ADDENDUM # 1

Quechee State Park – Upgrades

Date: October 21, 2021

STATE OF VERMONT
Forests, Parks & Recreation

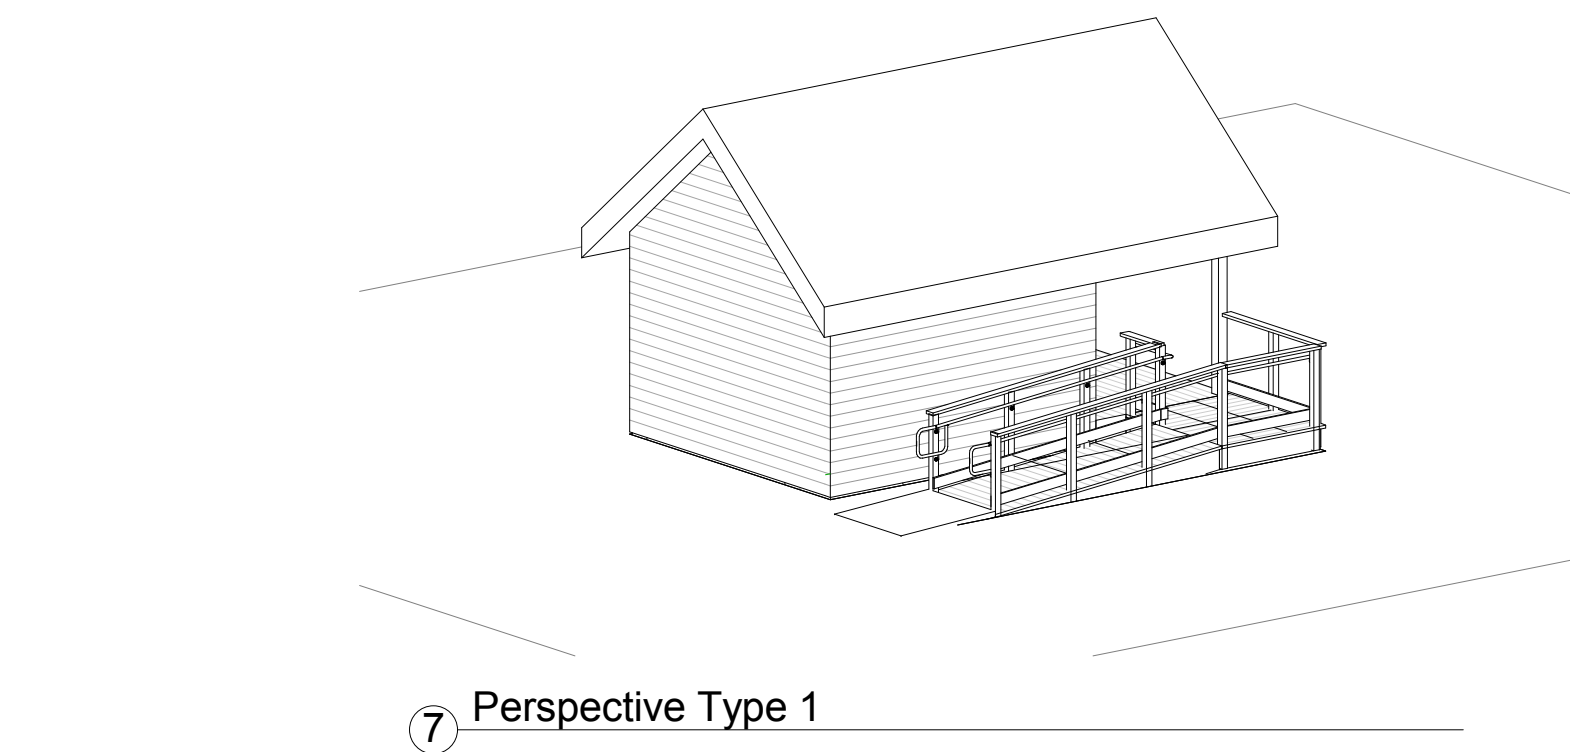
- Please see additional Cabin Ramp plans, two sheets numbered A1 & A2 by Cole Engineering & Construction. These were mistakenly omitted from the original bid set. All six cabins will have an ADA accessible ramp joining the front porch. There are two ramp options shown and which option will be determined in the field for each cabin. Please provide a price for each type of ramp - Add/Alternate #1 for Ramp Type #1 and Add/Alternate #2 for Ramp Type #2.
